Job Ref: B4726P-A1-DA1

Re: Request to Change Development Approval Under S.78 Of The Planning Act 2016

Street Address: 685 Wynnum Road, Morningside QLD 4170

Council Ref: A006579406

Extract A: Building B South Elevation (Source: AEC Australia)

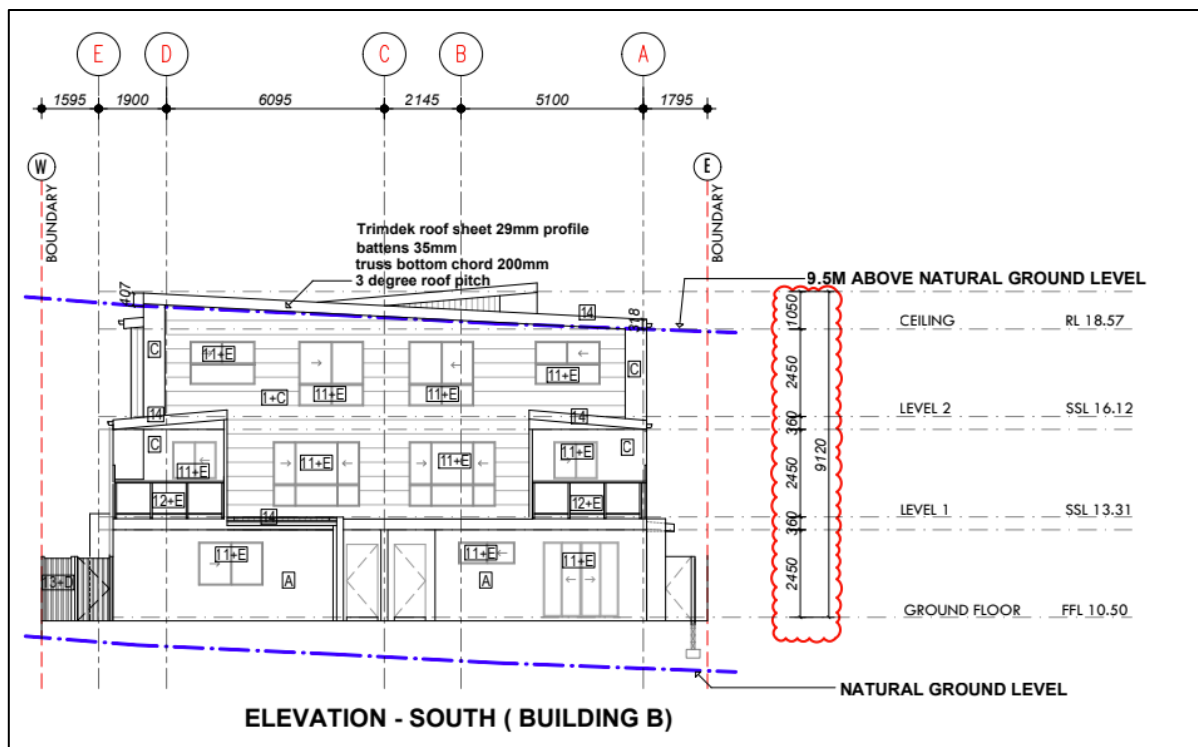
As part of the detailed design and construction phase, amendments have been made to the approved building height. Specifically, the actual height of Building B (comprising Units 5 and 6) at the rear of the development, is now slightly over the approved 9.5 m building line as shown on the endorsed Architectural Plans. This minor variation is the result of unforeseen site conditions encountered during construction, including the following:

- The Ground Floor RL was raised to RL 10.50 (from RL 10.45) to address on-site sewer and stormwater civil constraints;
- The structural floor framing depth was increased from 300 mm to 360 mm; and
- The minimum structural floor-to-ceiling height of 2,450 mm has been maintained.

As such, there has been a minor increase in overall building height, however the variation is attributed exclusively to technical compliance requirements and inherent site conditions, and does not generate any additional amenity, privacy, or overshadowing impacts.

Approved Plan	Proposed Plan
GROUND FLOOR PLAN	
Unit 1 RL 10.00	Unit 1 RL 10.30
Unit 2 RL 10.15	Unit 2 RL 10.30
Unit 3 RL 10.20	Unit 3 RL 10.40
Unit 4 RL 10.30	Unit 4 RL 10.40
Unit 5 RL 10.45	Unit 5 RL 10.50
Unit 6 RL 10.45	Unit 6 RL 10.50
LEVEL ONE FLOOR PLAN	
Unit 1 RL 13.15	Unit 1 RL 13.21
Unit 2 RL 13.15	Unit 2 RL 13.21
Unit 3 RL 13.15	Unit 3 RL 13.21
Unit 4 RL 13.15	Unit 4 RL 13.21
Unit 5 RL 13.20	Unit 5 RL 13.31
Unit 6 RL 13.20	Unit 6 RL 13.31
